ROCHESTER GAS AND HEATING CORPORATION • 19 EAST AVENUE, ROCHESTER, N.Y. 14610

February 1, 1982

Subject: SEP Topics VI-2.D and VI-3  
R. E. Ginna Nuclear Power Plant  
Docket No. 50-244

### COMMENTS ON NRC SAFETY EVALUATION

FIGURE 5  
CONTAINMENT PRESSURE  
STEAM BREAK H2P  
1/2 SPRAY SYSTEM

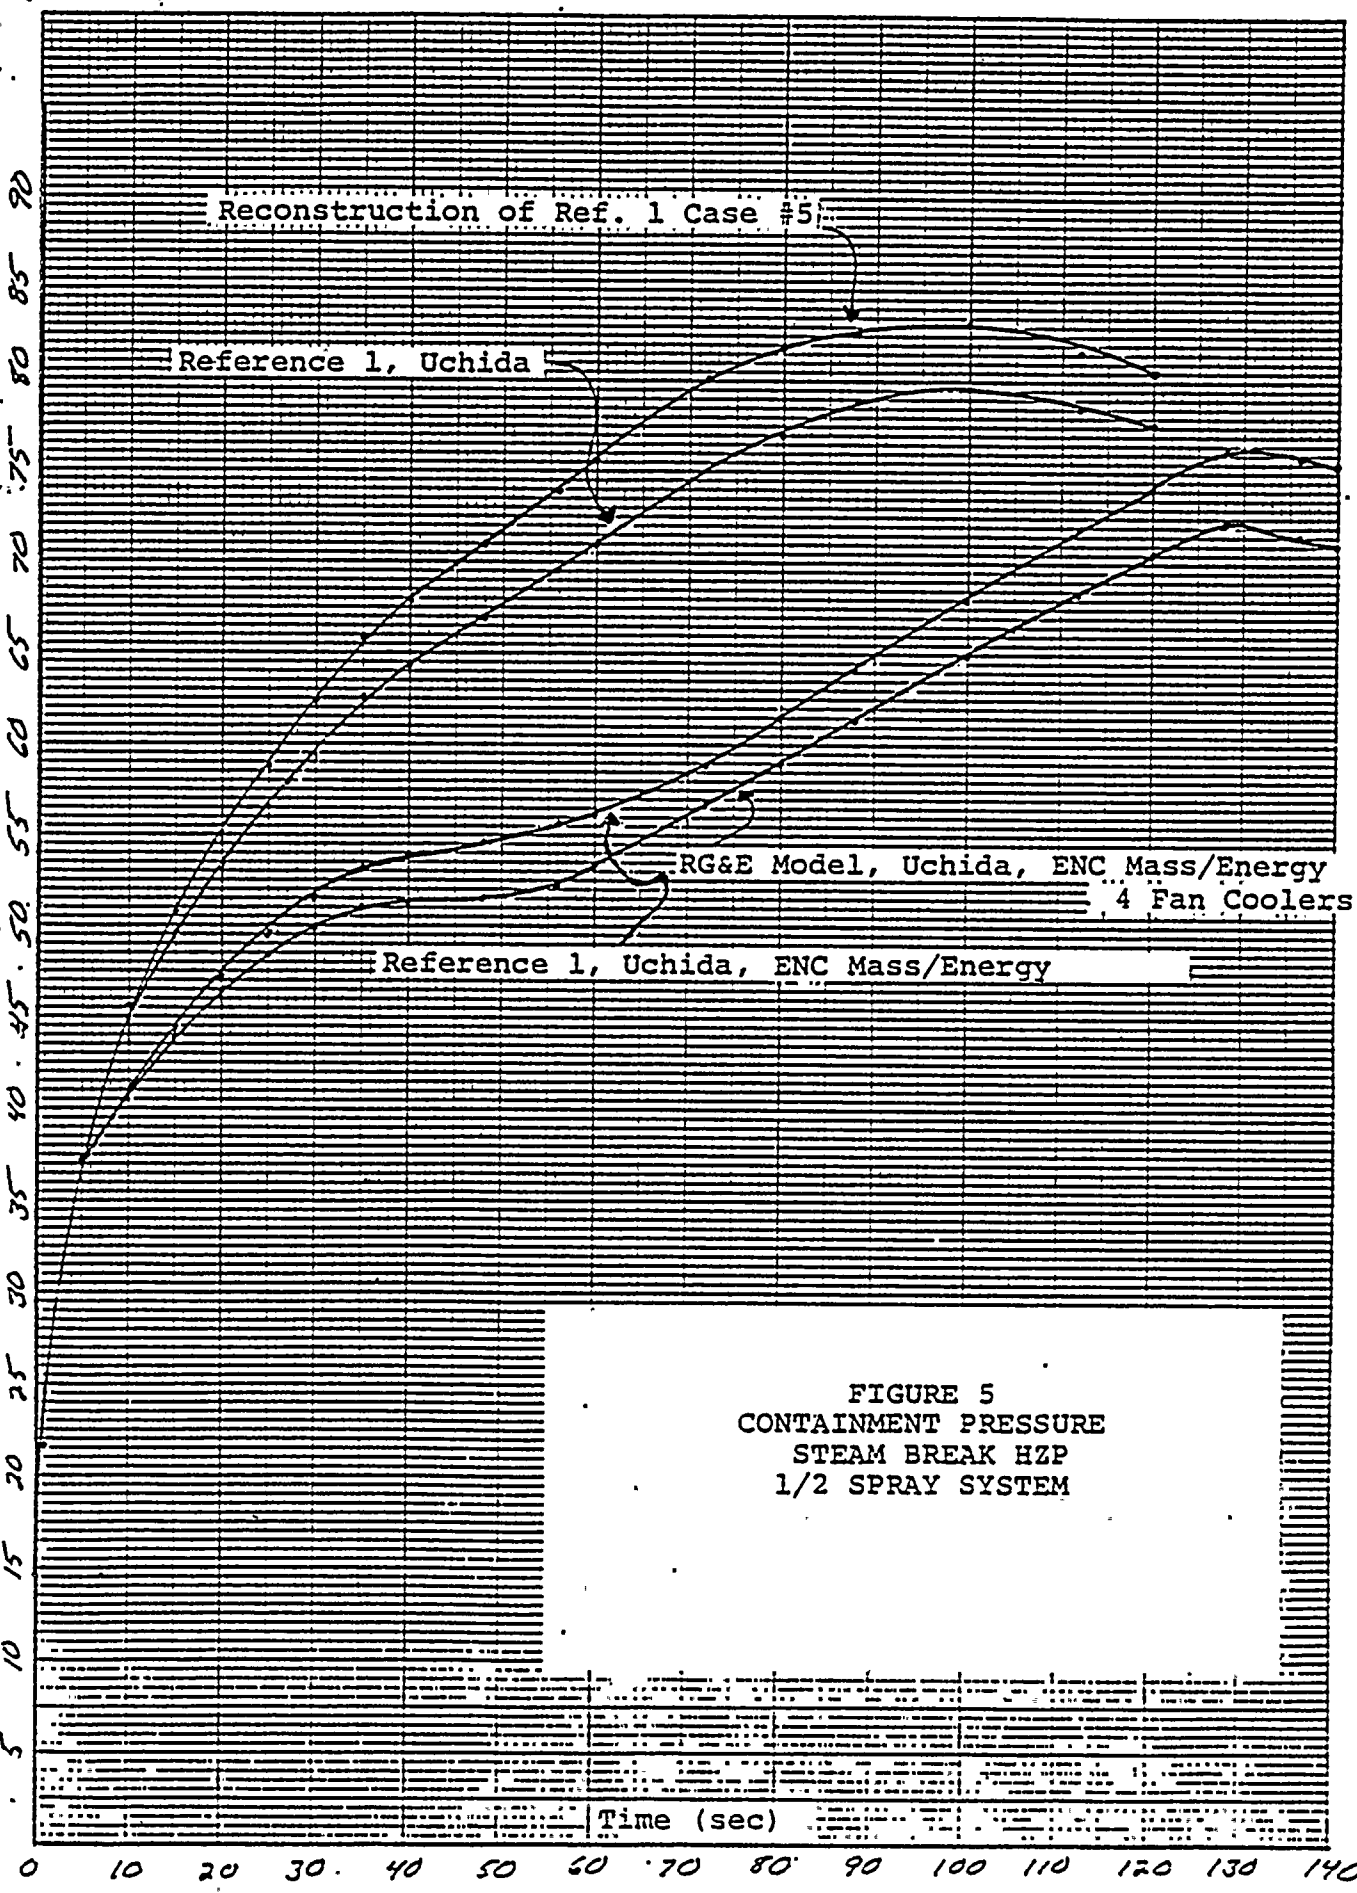
Figures 4 and 5 illustrate the effect of Uchida, ENC mass and energy, and the RG&E containment heat sink model on the worst case containment response presented in Reference 1 (#1, #4, #5, and #11 of Table 1).

FIGURE 1  
CONTAINMENT TEMPERATURE  
STEAM BREAK H2P  
1/2 SPRAY SYSTEM

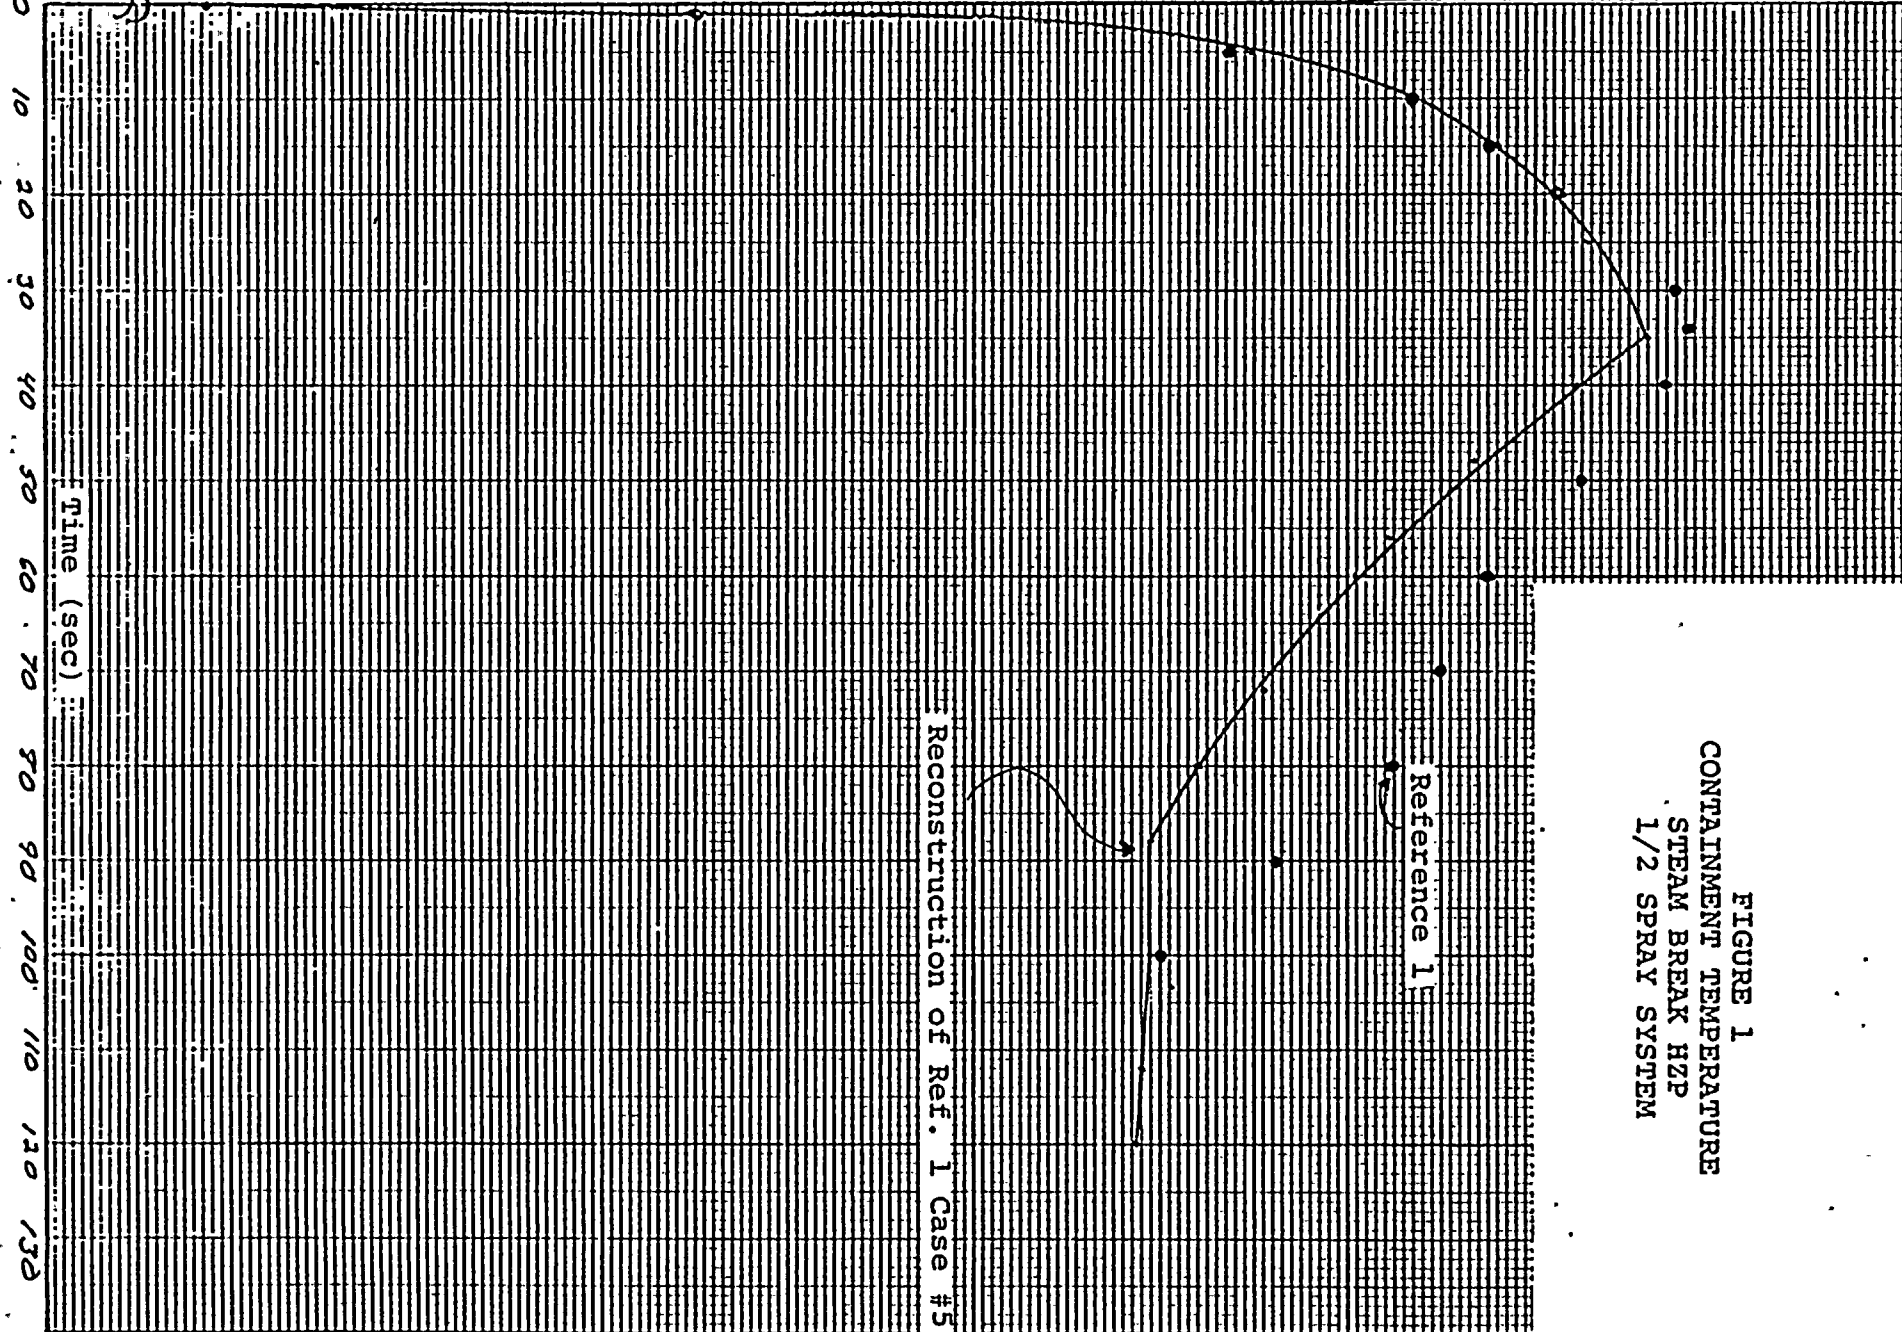
The highest containment pressure was calculated in Reference 1 to occur for a large steam line break at HZP with failure of one spray train. The input for this case was run using CONTEMPT-EI/28B. Figure 1 and 2 illustrates the results of this run and points taken from Reference 1. The following peak temperature and pressure was obtained:

FIGURE 4  
CONTAINMENT TEMPERATURE  
STEAM BREAK H2P  
1/2 SPRAY SYSTEM

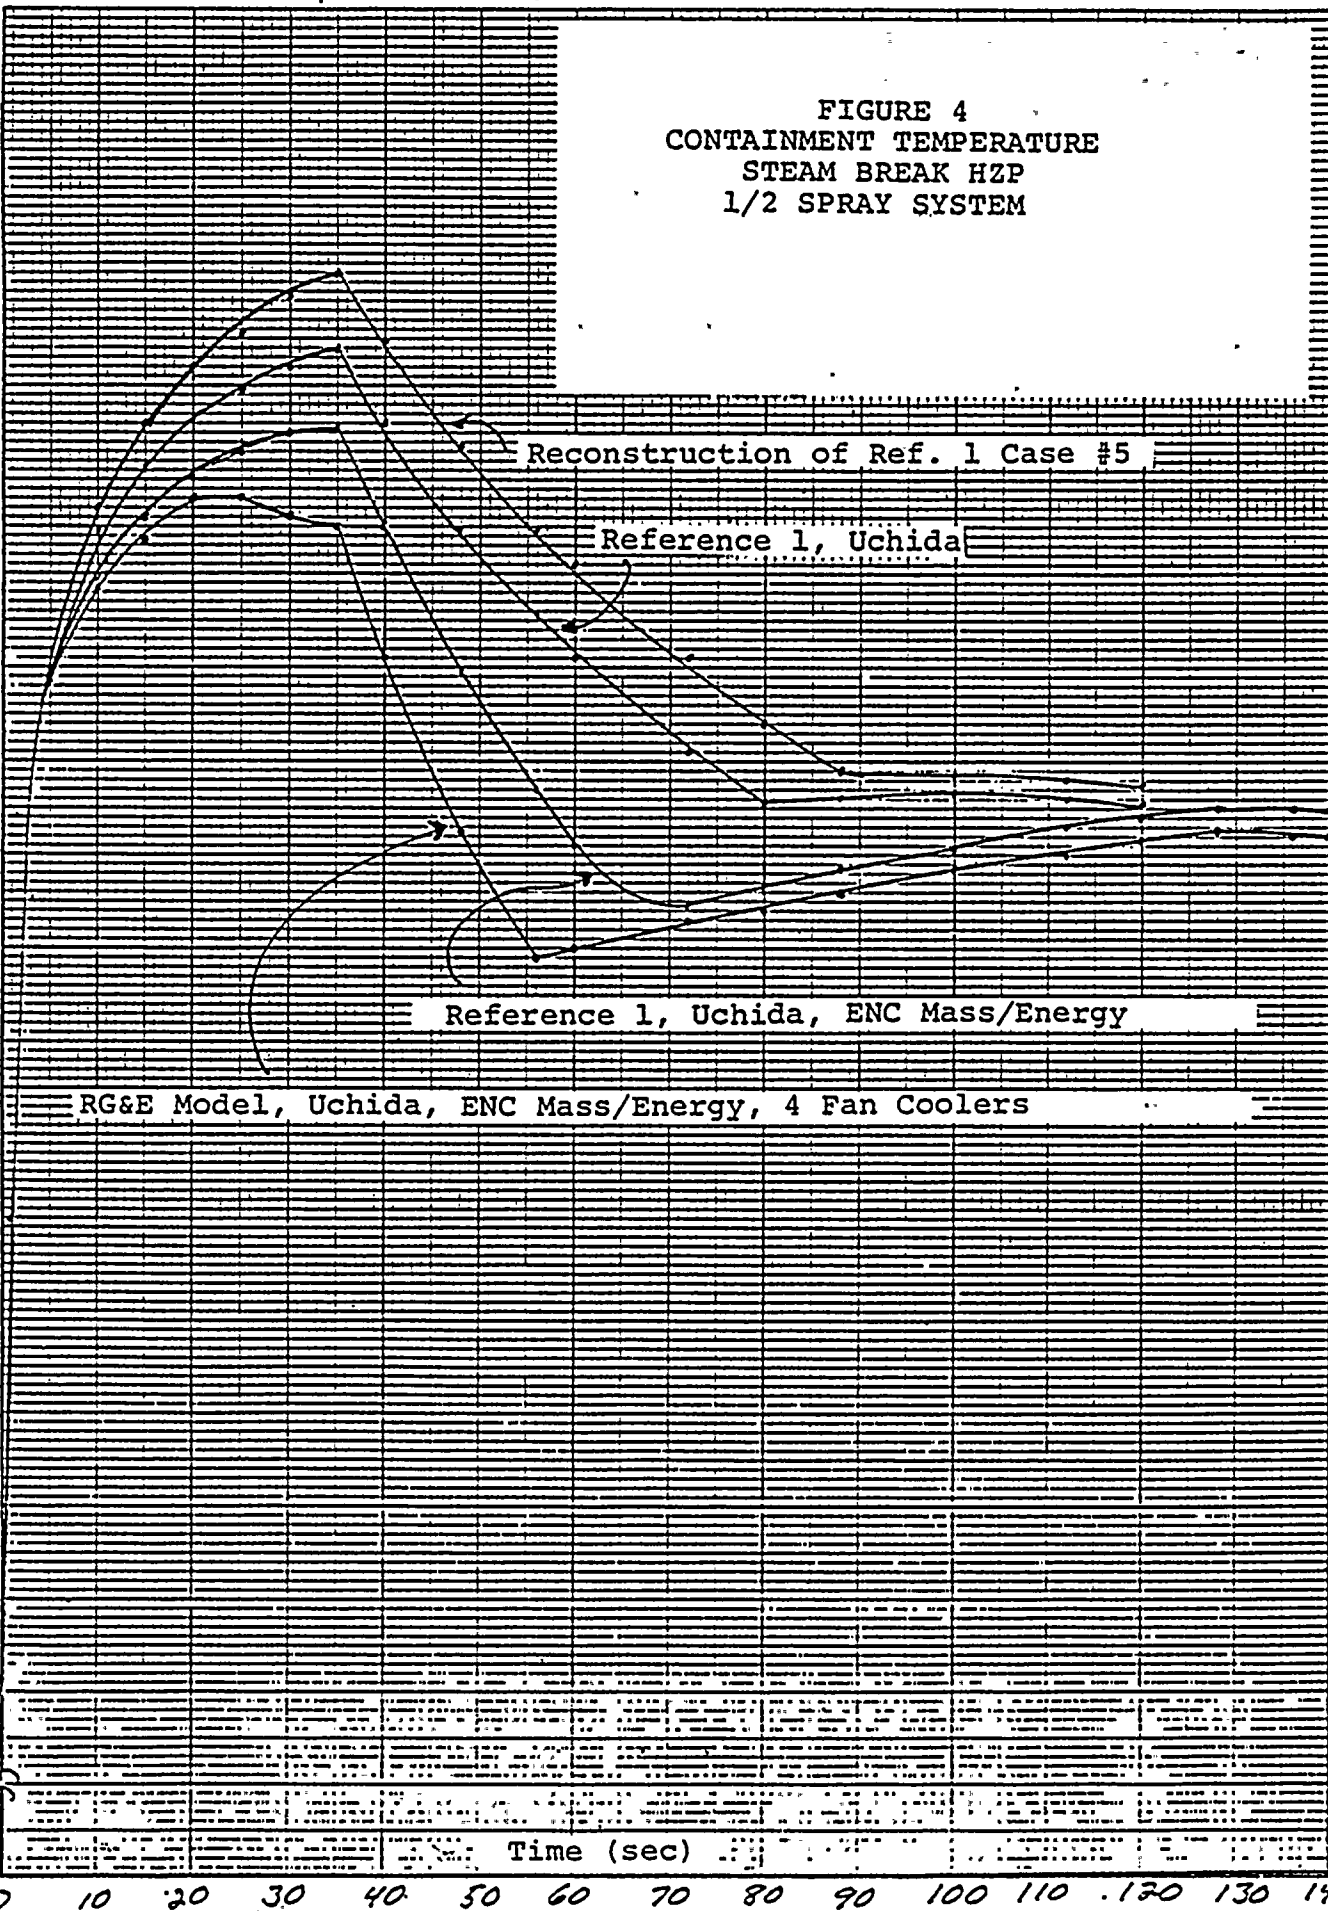
Figures 4 and 5 illustrate the effect of Uchida, ENC mass and energy, and the RG&E containment heat sink model on the worst case containment response presented in Reference 1 (#1, #4, #5, and #11 of Table 1).

FIGURE 1  
CONTAINMENT TEMPERATURE  
STEAM BREAK HZP  
1/2 SPRAY SYSTEM

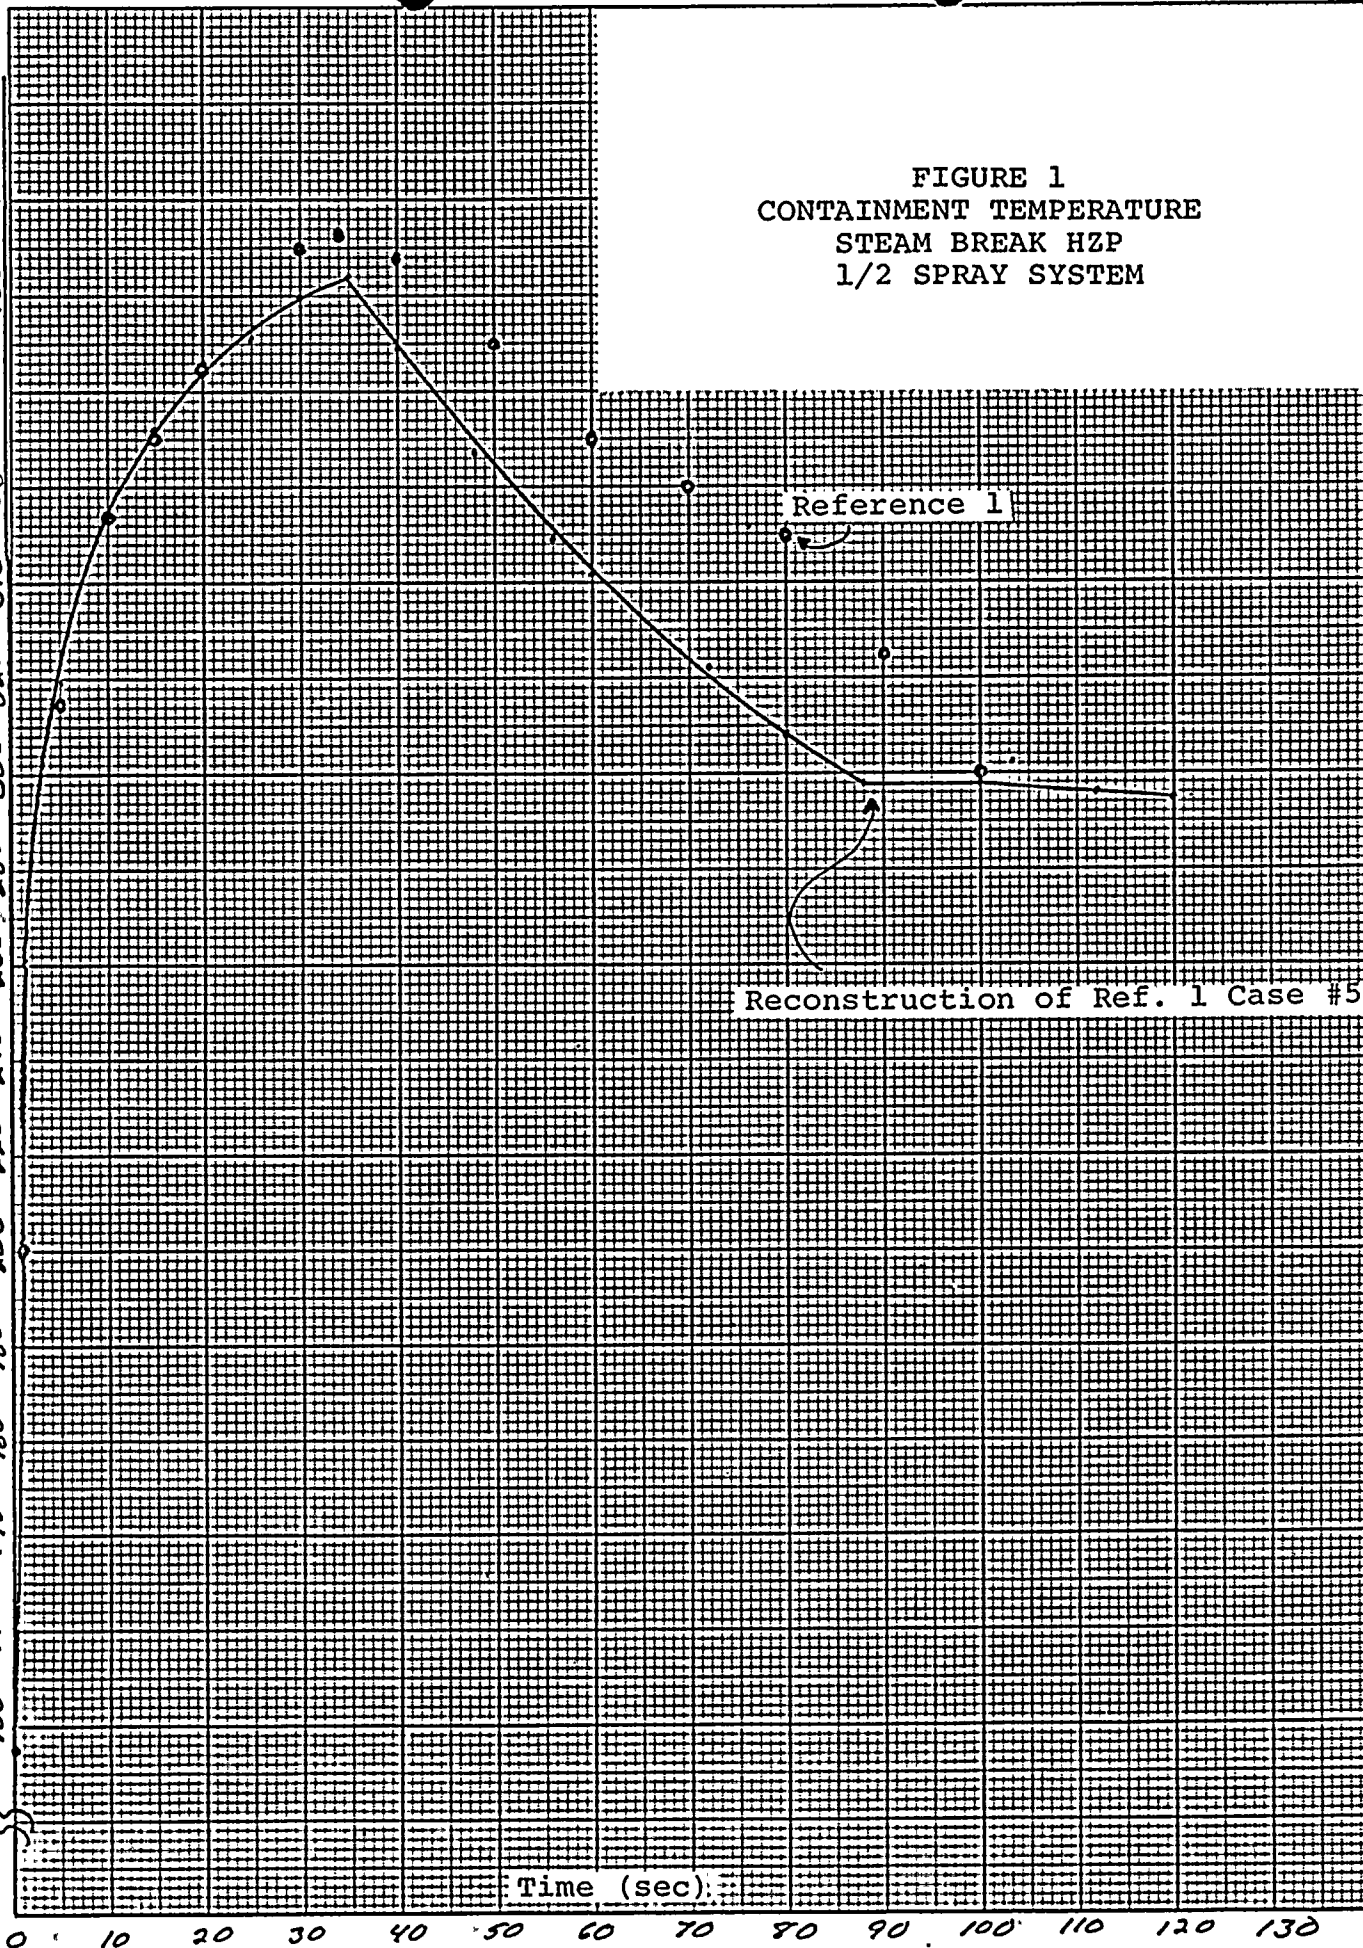
The highest containment pressure was calculated in Reference 1 to occur for a large steam line break at HZP with failure of one spray train. The input for this case was run using CONTEMPT-EI/28B. Figure 1 and 2 illustrates the results of this run and points taken from Reference 1. The following peak temperature and pressure was obtained.
